**PRODUCT IMPROVEMENT PROGRAM FOR REPLACING THE AFTERTREATMENT
REGENERATION DEVICE (ARD) COMBUSTION BODY ON CERTAIN C15 ON-HIGHWAY
TRUCK ENGINES**

Media Number -REBE4750-01

07Jan2009
(Revised 28Jan2009)

SAFETY - RECALL- REPLACEMENT OF THE AFTERTREATMENT REGENERATION
 DEVICE BODY

Image1.1.1

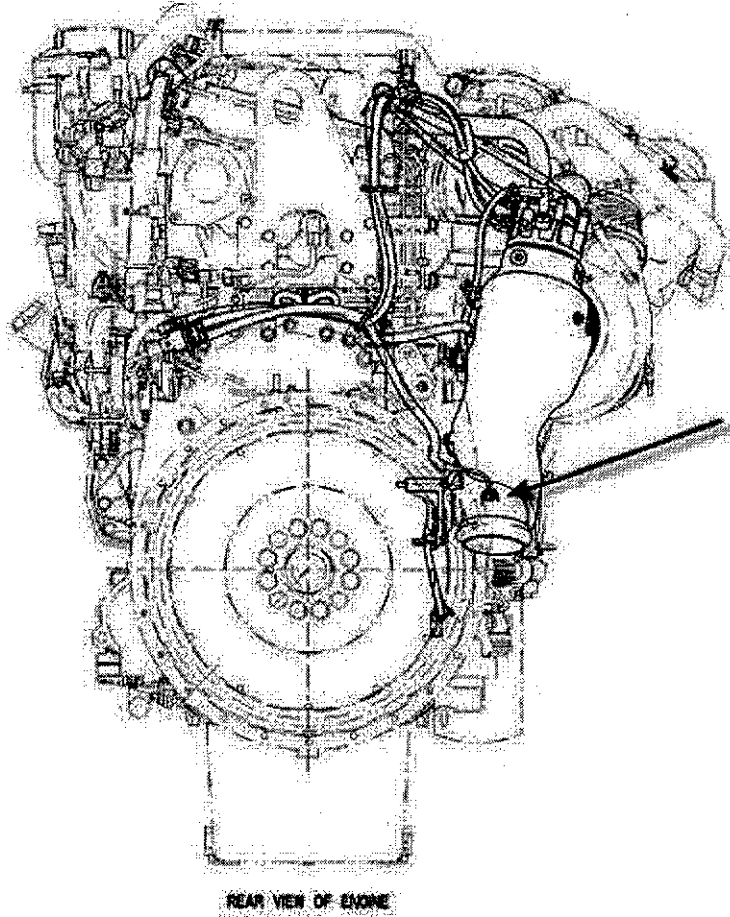
1. Perform an ECM warranty download using Cat ET.
2. Remove combustion head group (ARD). Refer to RENR9706 "Combustion Head Group (ARD) - Removal Procedure".
3. Loosen the OEM band clamp at the bottom of the combustion body and remove the extension pipe attached to the combustion body.
4. Disconnect the temperature sensor located at the bottom of the combustion body. Refer to Image 1.1.1

11. Install the two bolts that attach the combustion body to the support bracket. Refer to Image 1.2.1
12. Apply anti-seize compound to the threads of the temperature sensor located at the bottom of the combustion body and install. Refer to Image 1.1.1

Image1.1.2

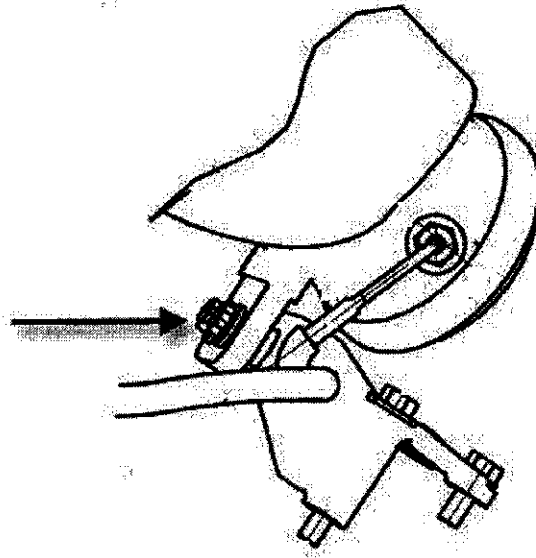
5. Remove the two bolts that attach the combustion body to the support bracket. Refer to Image 1.1.2
6. Disconnect the temperature sensor located on the back of the combustion body near the top.

Image1.2.1

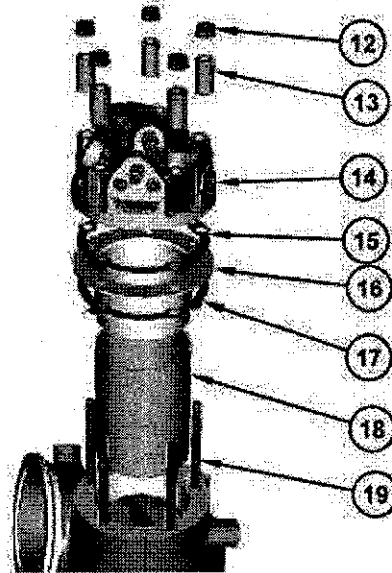
15. Apply anti-seize compound to the threads of studs (19). Install studs (19) with the end that is marked "X" in the Up position. Tighten studs (19) to a torque of 17 +/- 2 N.m (12.5 +/- 1.5 lb ft). Install tube (18). Refer to Image 1.2.1 and Image 1.2.2

Image1.3.1

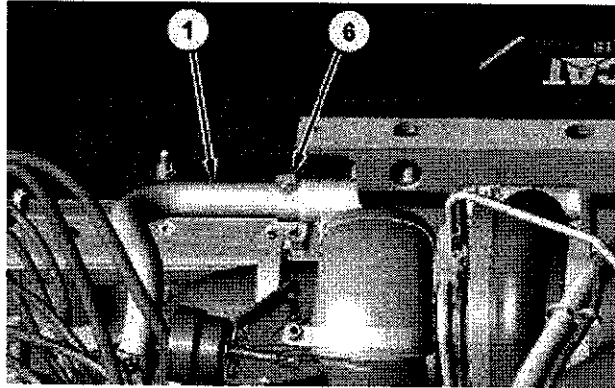
17. Install a new 289-3107 gasket (not pictured) between the 288-6036 tube assembly (1) and ARD Head. Tighten clamp (6). Refer to Image 1.3.1
